**CITY OF WEST DES MOINES
MEMORANDUM**

TO: Chairperson Andersen and Members of the Plan and Zoning Commission
FROM: Bryce C. Johnson
DATE: June 28, 2021
RE: Item 2a, Westowne Center Planned Unit Development

Exhibit I

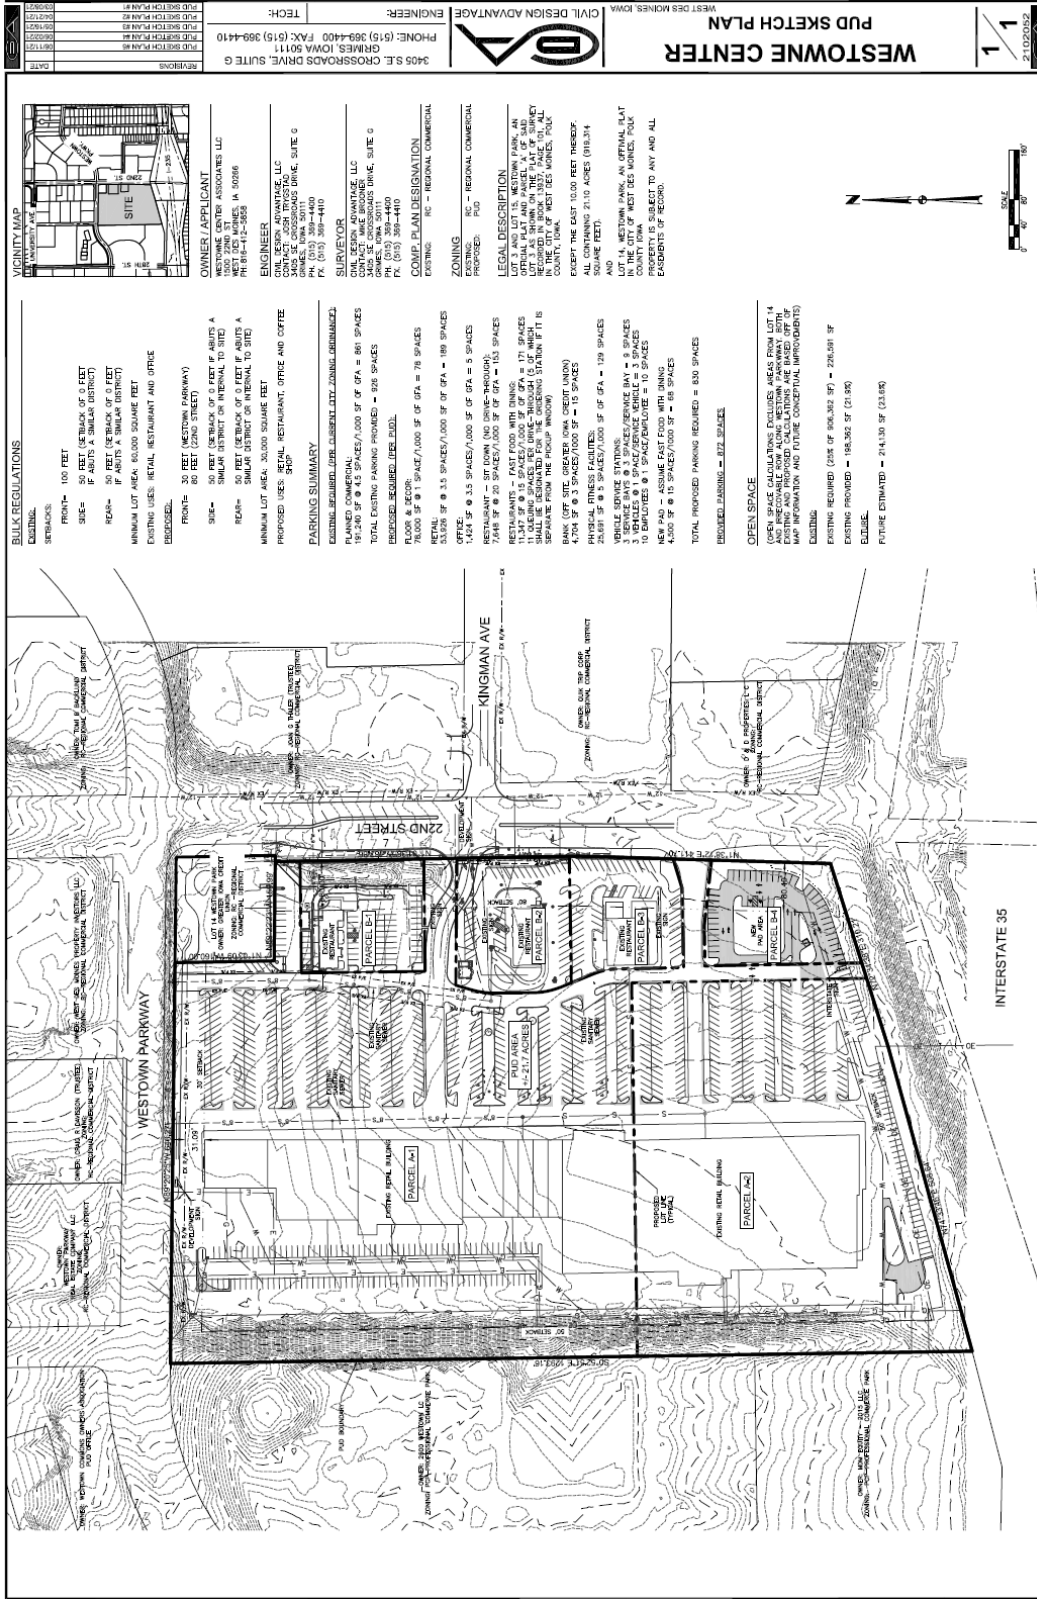
- 1) ~~Any existing situation(s) not impacted by existing lease agreements~~The area identified on Exhibit I shall be restriped accordingly to comply with minimum city code regulations in conjunction with asphalt overlays (top coating) or implementation of underground storm water detention facilities or full depth pavement reconstruction of parking area(s) occurs, whichever allows the earliest opportunity to restripe.

- c. ~~Existing~~ The existing striped paved islands identified on Exhibit I shall be modified to vegetative islands consistent with city code regulations for incorporation of terminal islands and tree pods at such time that the implementation of underground storm water detention facilities or full depth pavement replacement (not just top coating) of parking lot areas occurs.
